ADDENDUM NO. #0

TRACK & FIELD IMPROVEMENTS

Channel Islands High School

April 10, 2020

AD0-C2 C2.0

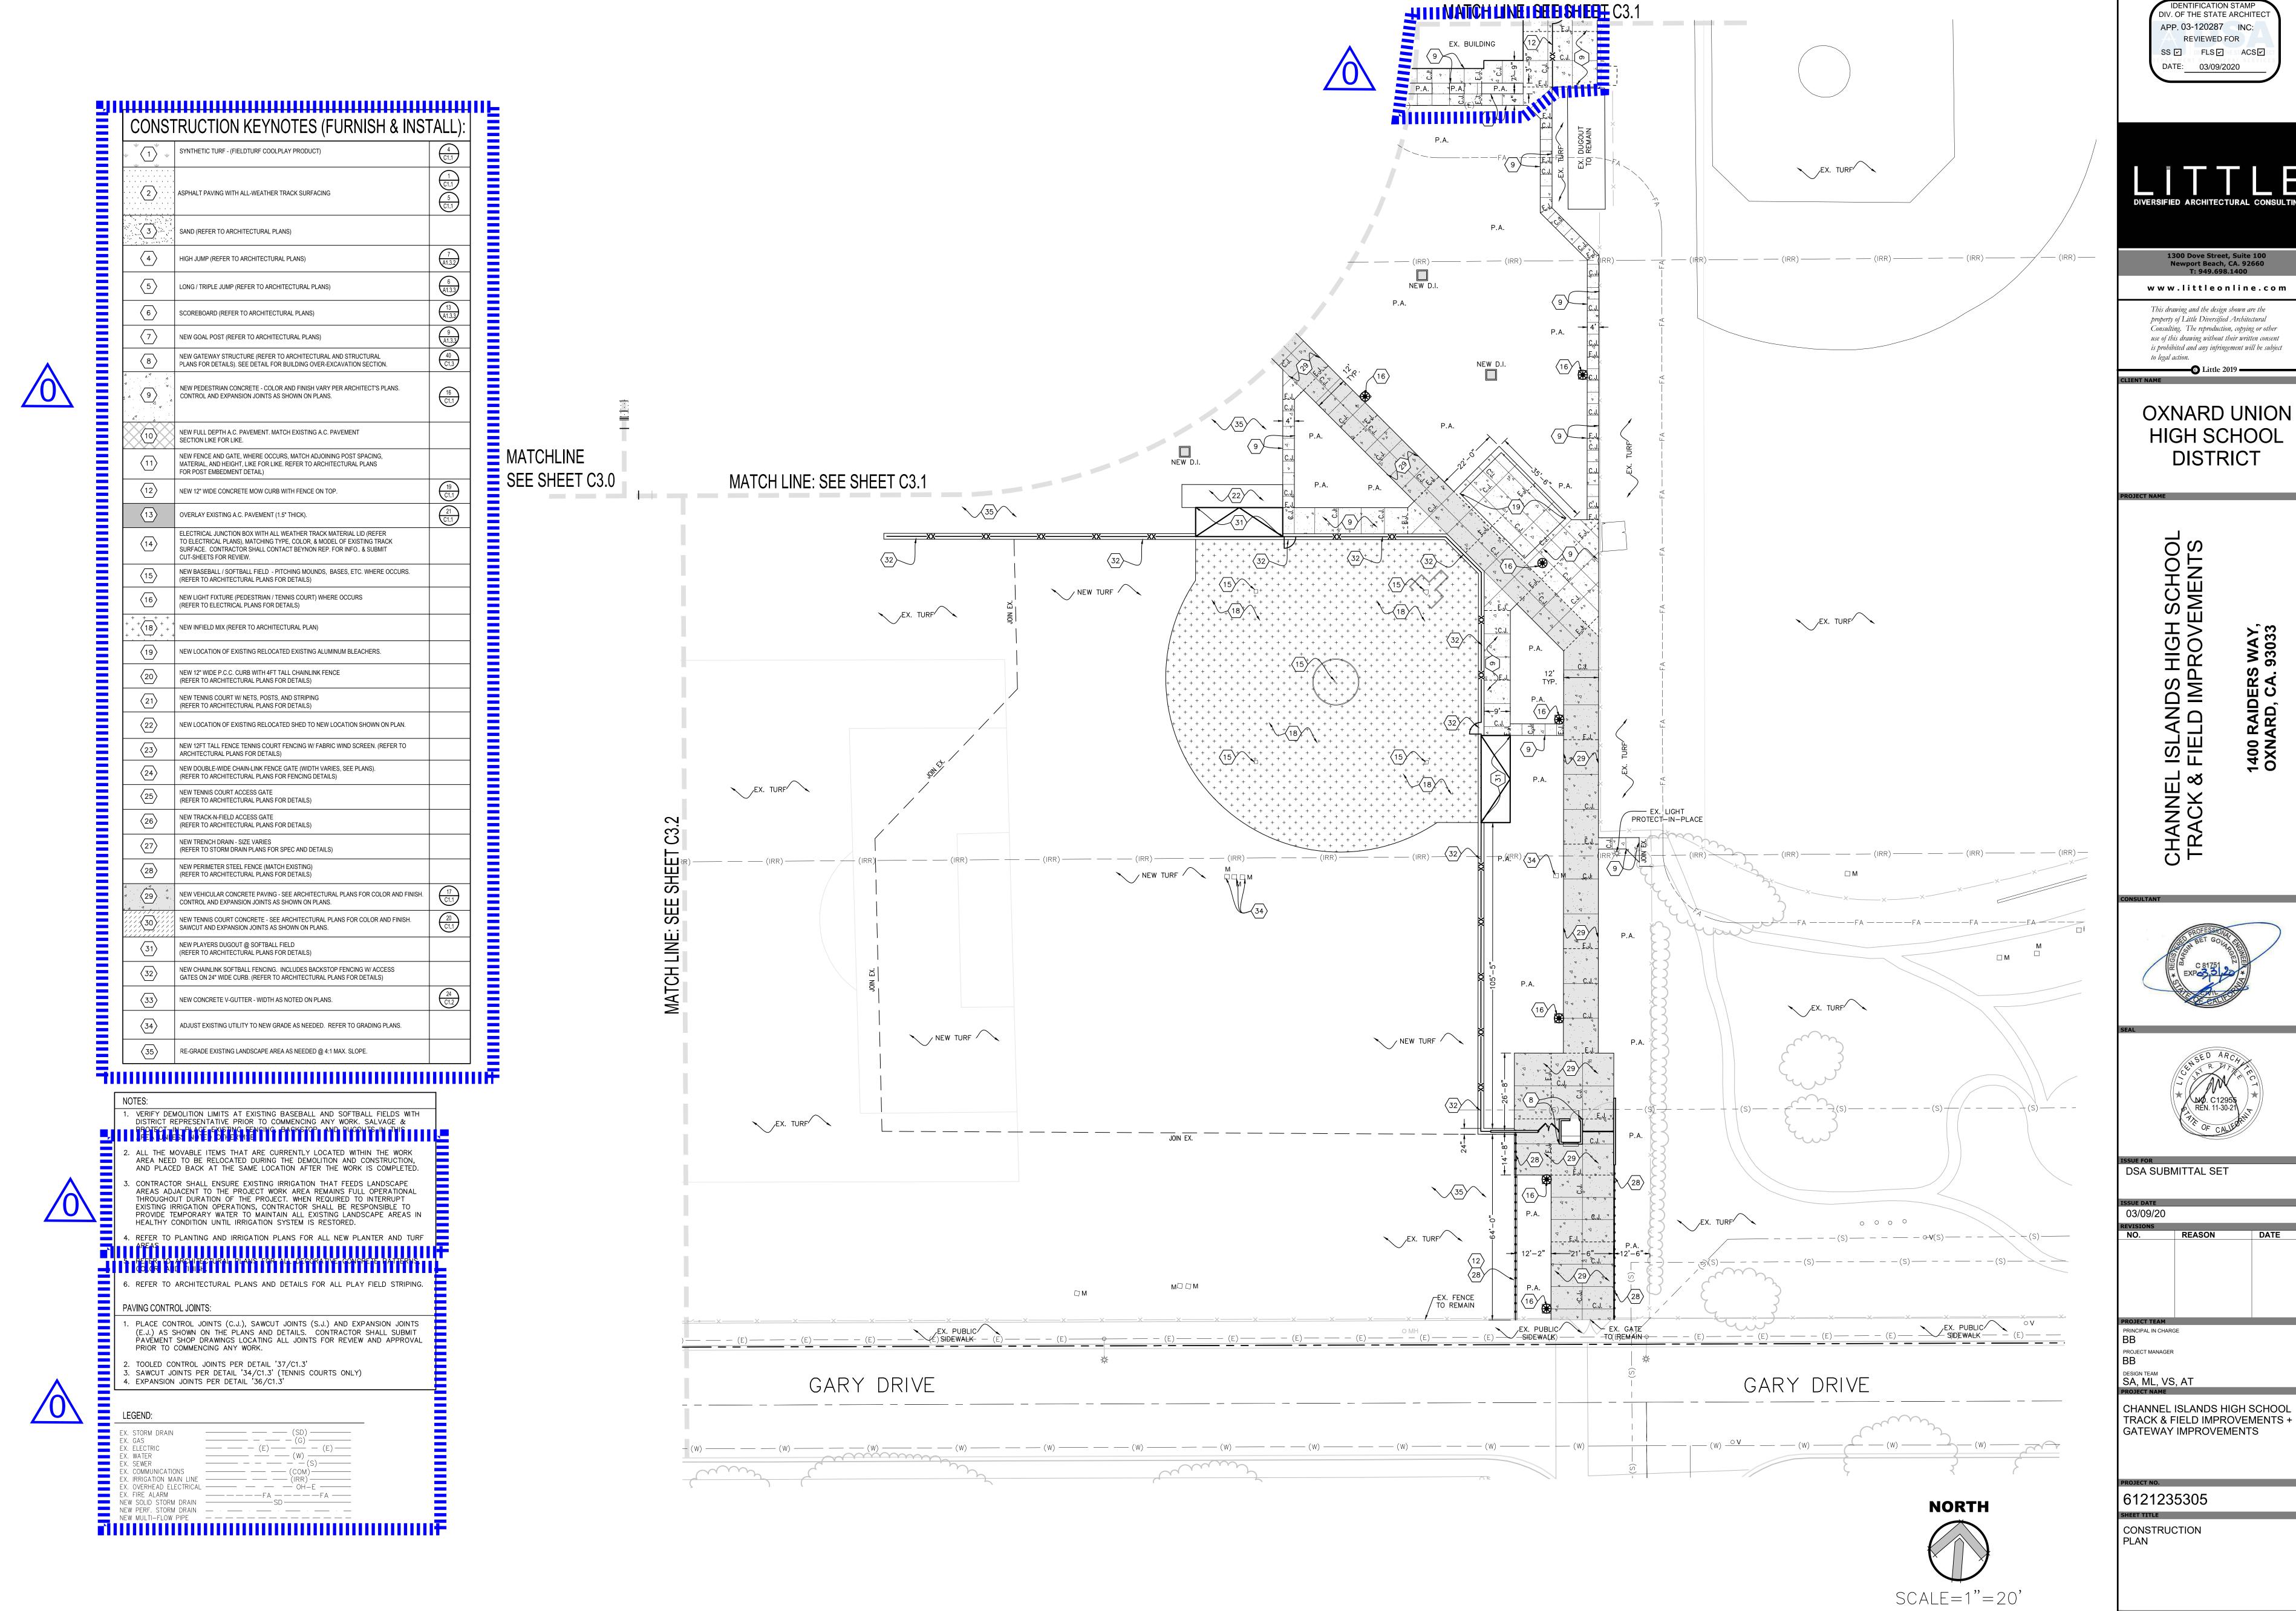
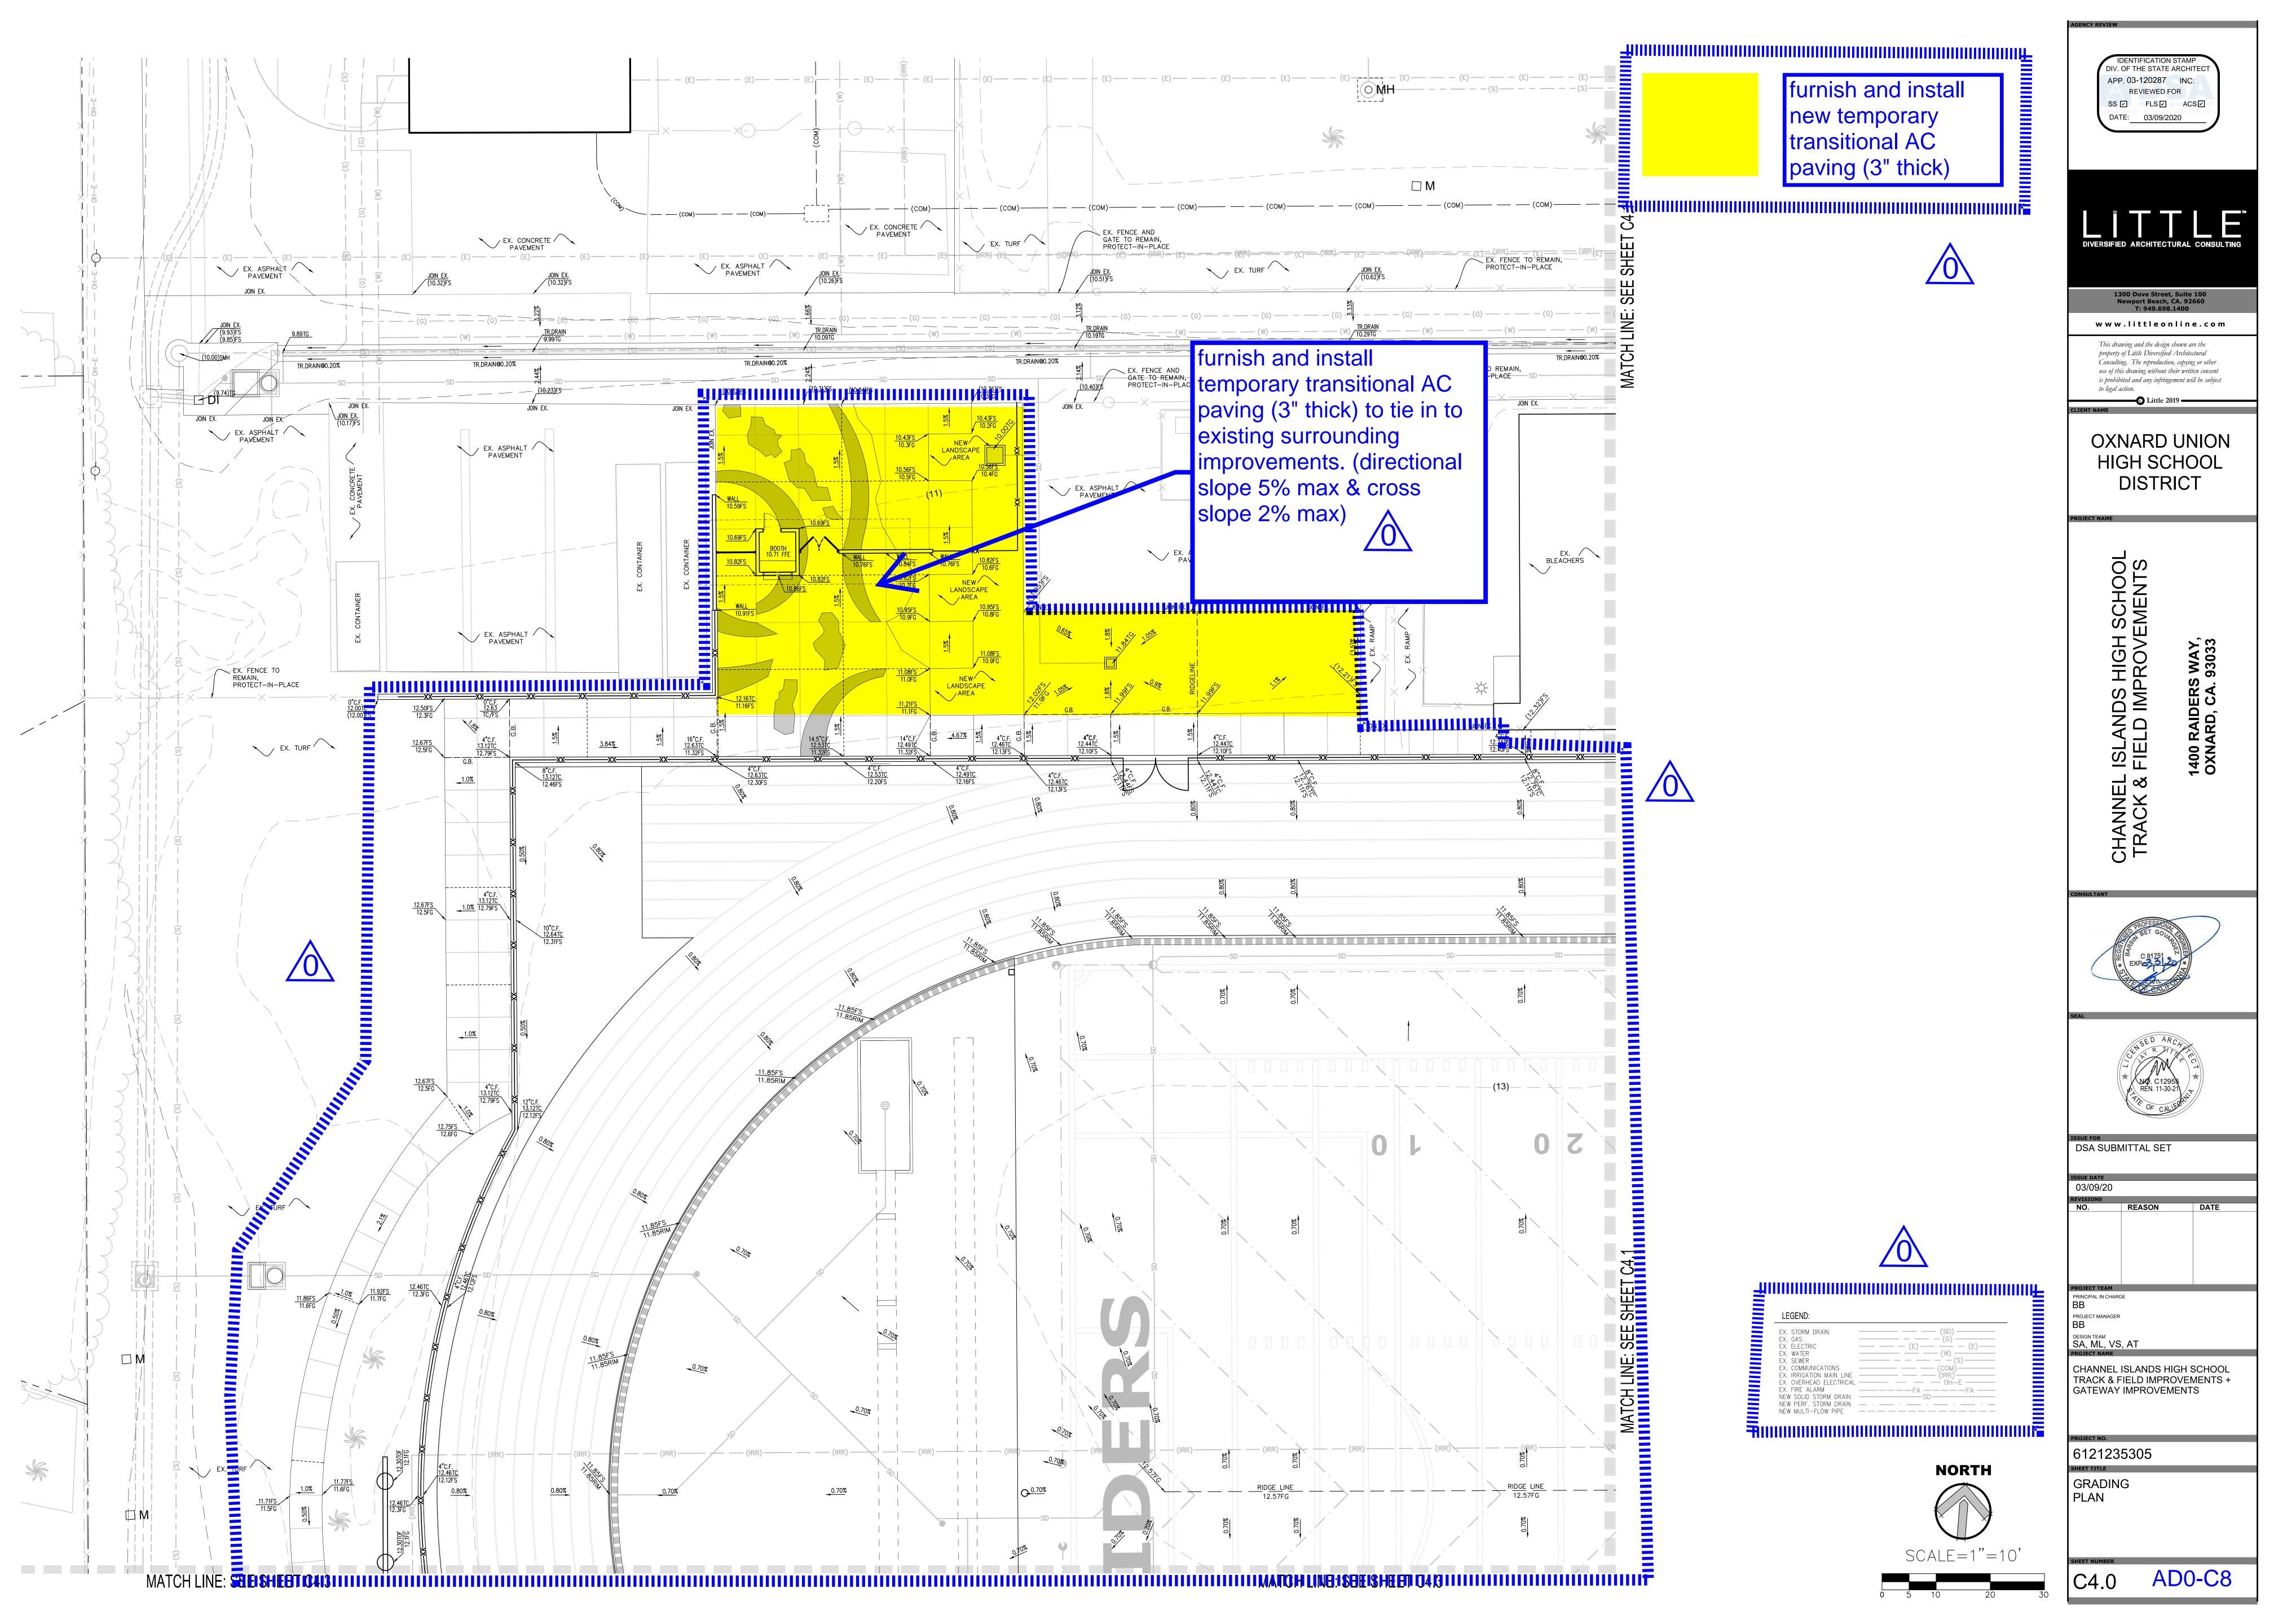
- **3.1.2.2.** Drawing C2.0/AD0-C2 Only work within outlined area is included in scope of this project and bid. Any work shown outside of the delineated area is not part of this project.

AD0-L1

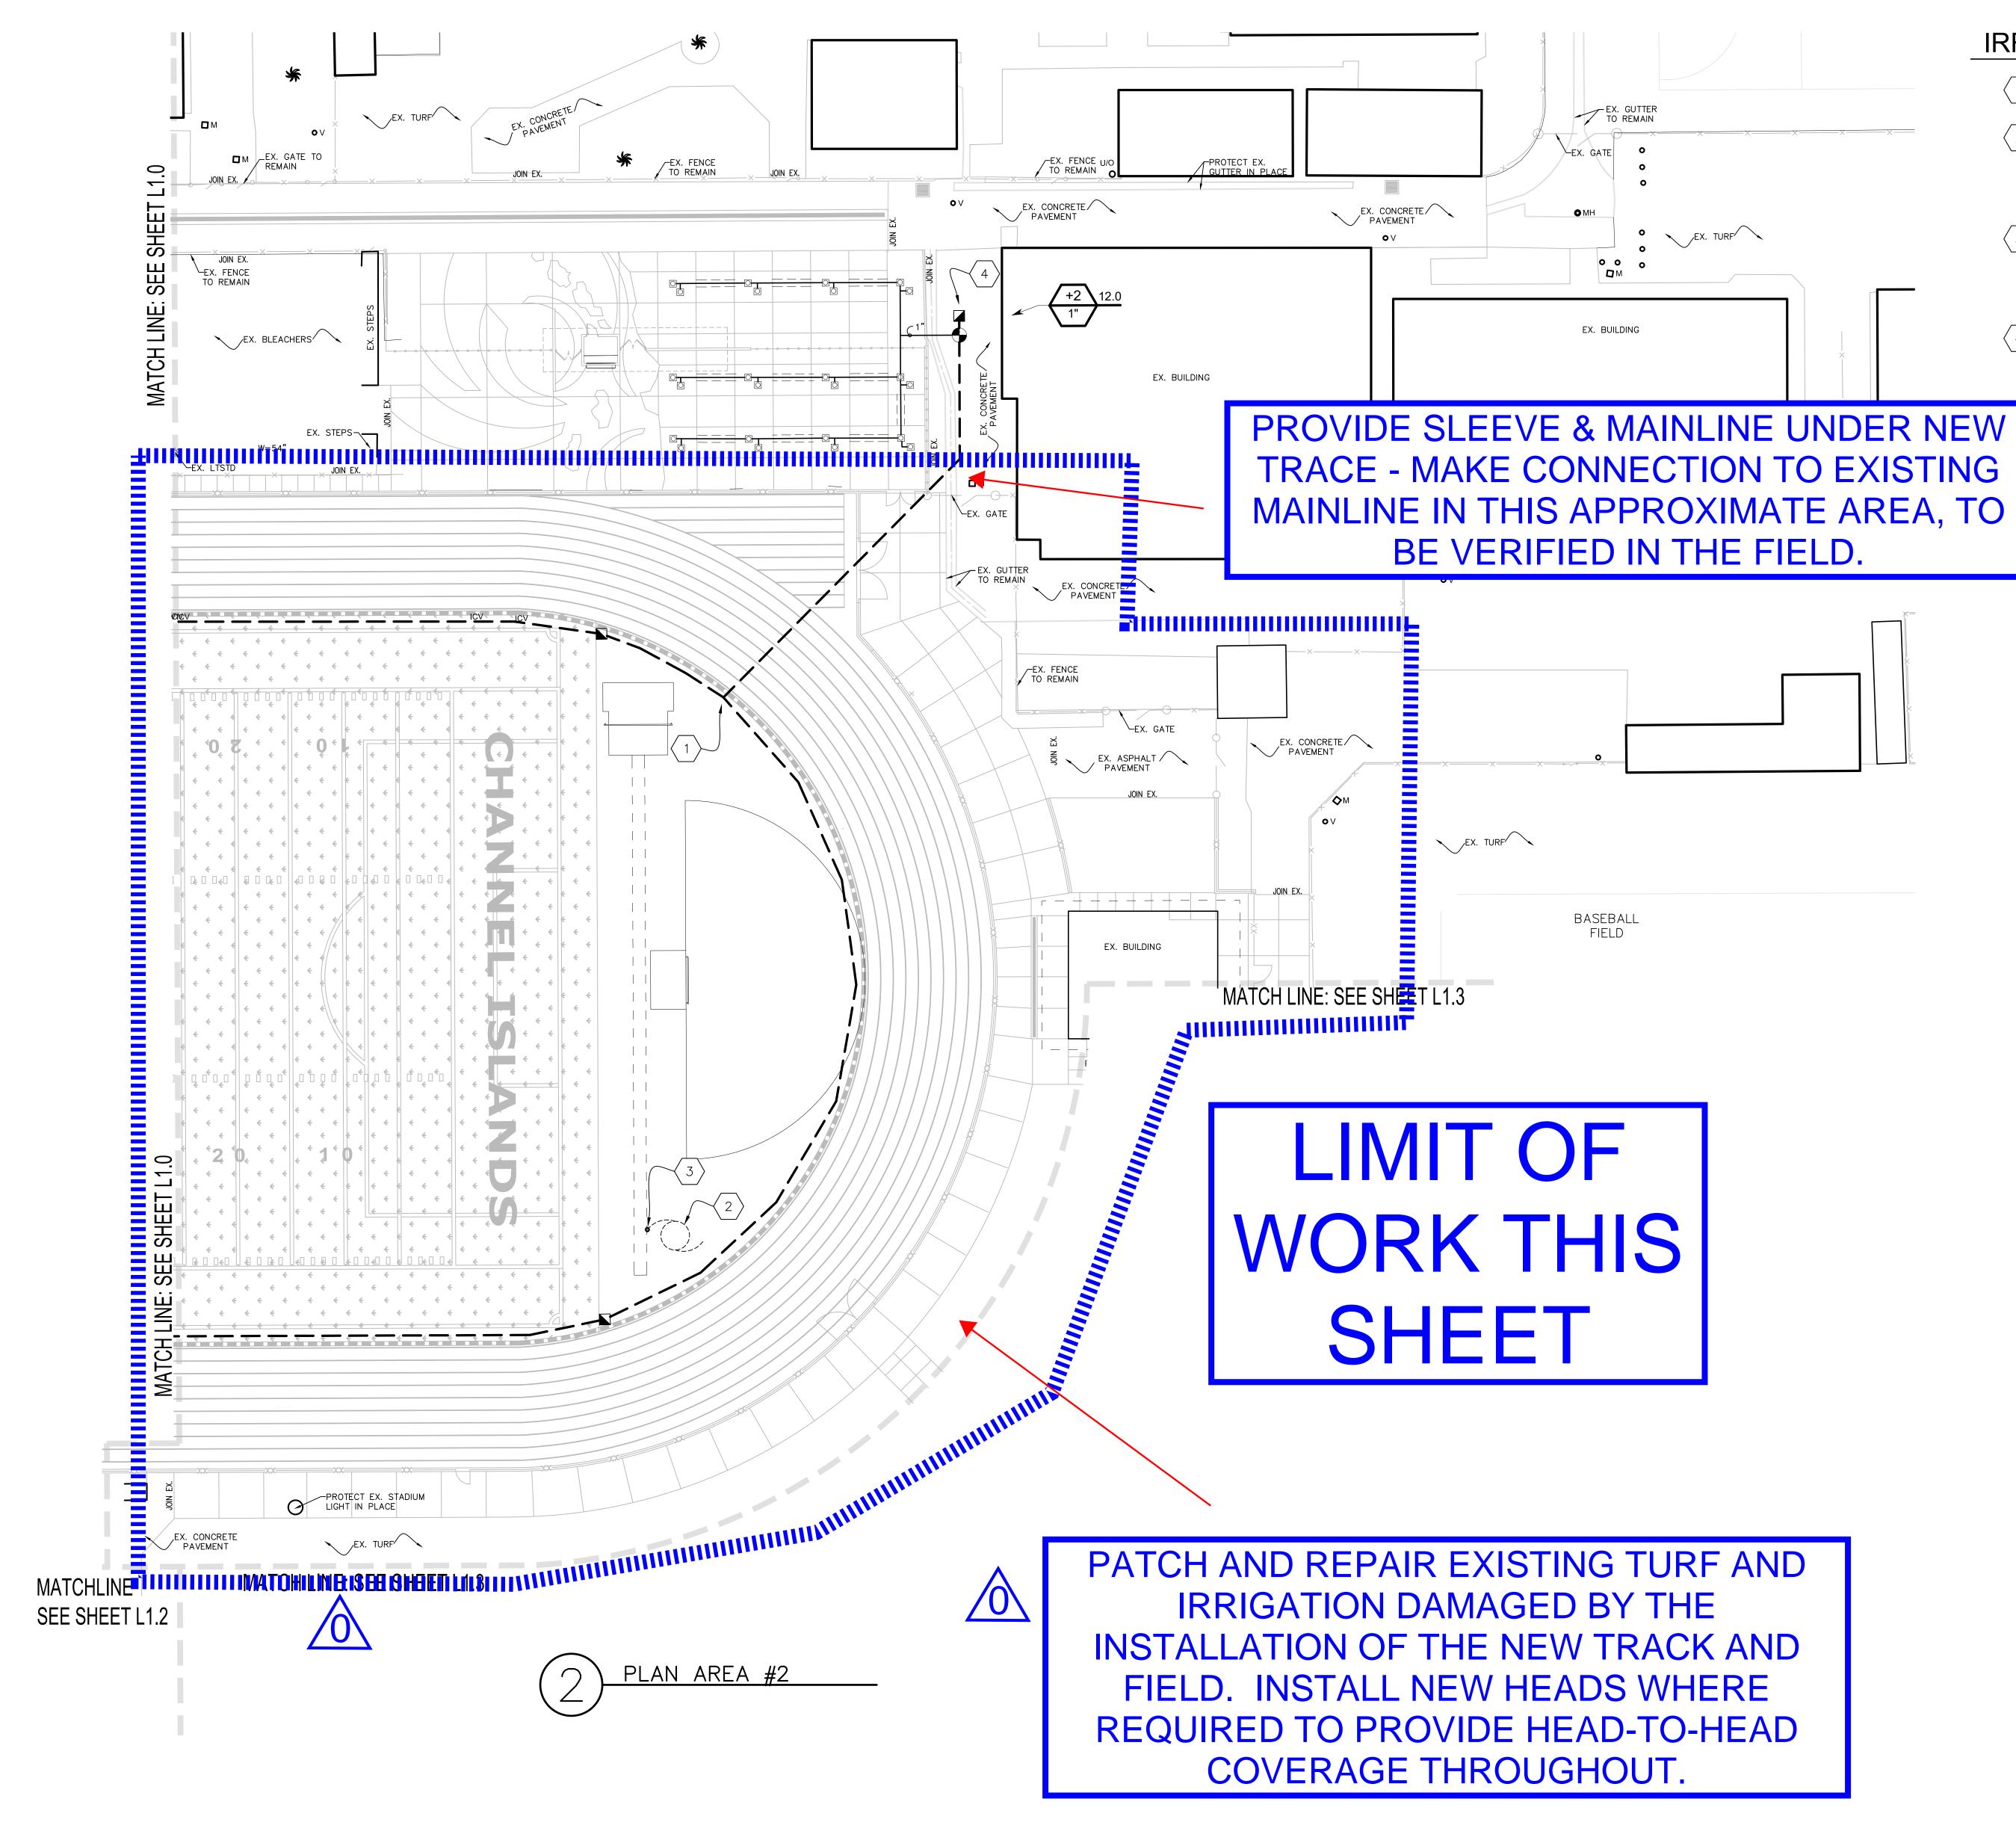
- 3.2.2.1. Drawing L1.0/AD0-L1 Area of work has been revised as shown on this sheet. Notes added to indicate mainline and sleeve crossing new track with connection to existing irrigation loop. Contractor also needs to provide an allowance to repair/replace existing irrigation damaged by POT improvements around edge of track.
